Client
Muse Developments Ltd

Project Title
New Victoria

Explanation
of SuDS
Usage

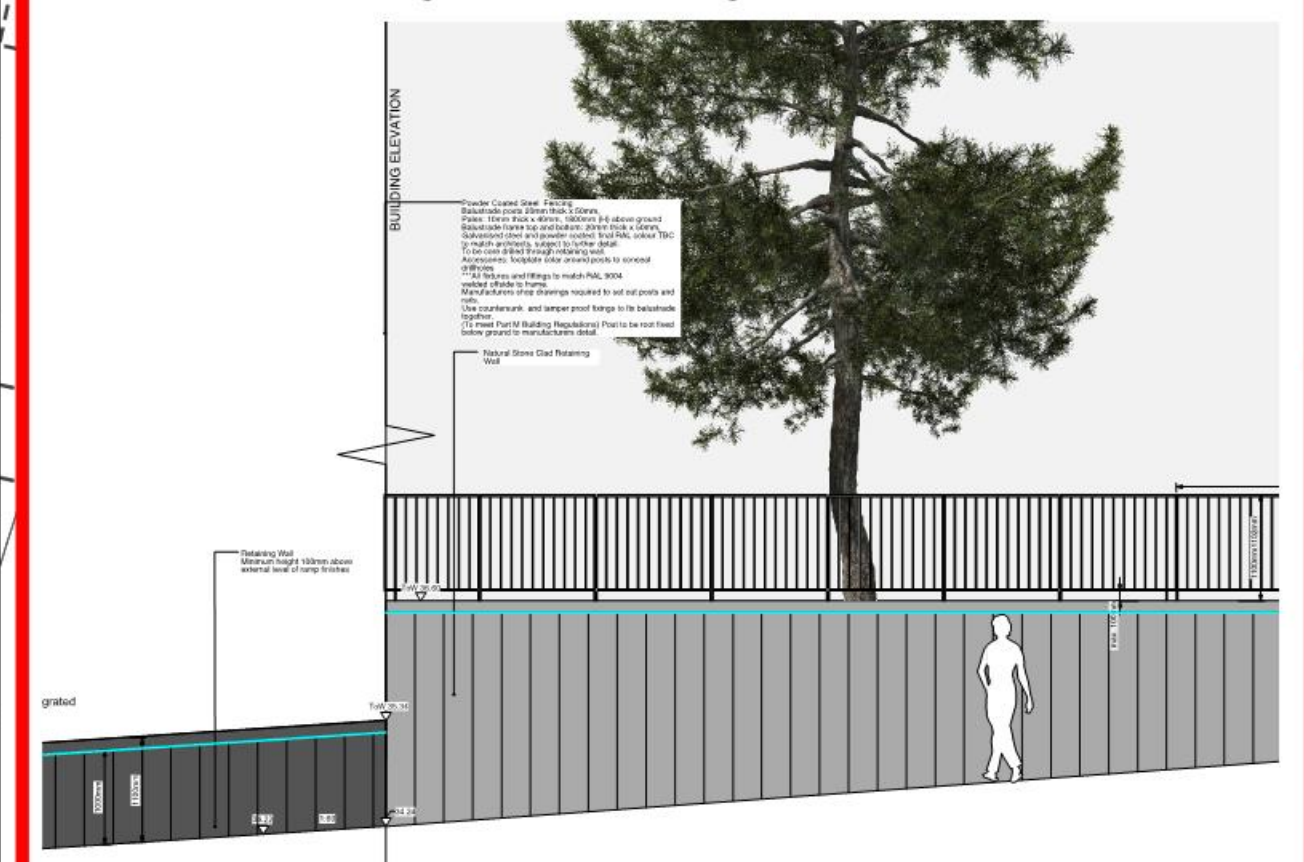
These tree pits are raised planters to avoid the pile caps and foundations beneath. Therefore levels do not allow drainage to discharge into them.

These vegetated areas are part of the temporary car park until the Phase 2 office building is constructed.

We have managed to utilise the raised ground levels along the ramp to discharge into this raised planter. Do to the large size of this planter, it can accommodate up to 4.5m³ of storm water attenuation. As this bio-retention tree pit is above ground, it will not clash with the below ground attenuation tank.

These trees are within raised planters to act as public realm seating and provide wind mitigation - therefore the drainage is deeper than the base of the tree pits.

This area is adjacent to the Metrolink and so levels have been designed specifically to avoid draining onto this land, to prevent surface runoff from our site.

This tree pit is situated on the site boundary, therefore levels specifically aim to drain away from here.

This area is a raised podium. Therefore, shallow channel drains are utilised within the structural deck, a deeper outfall from a tree pit could not be accommodated.
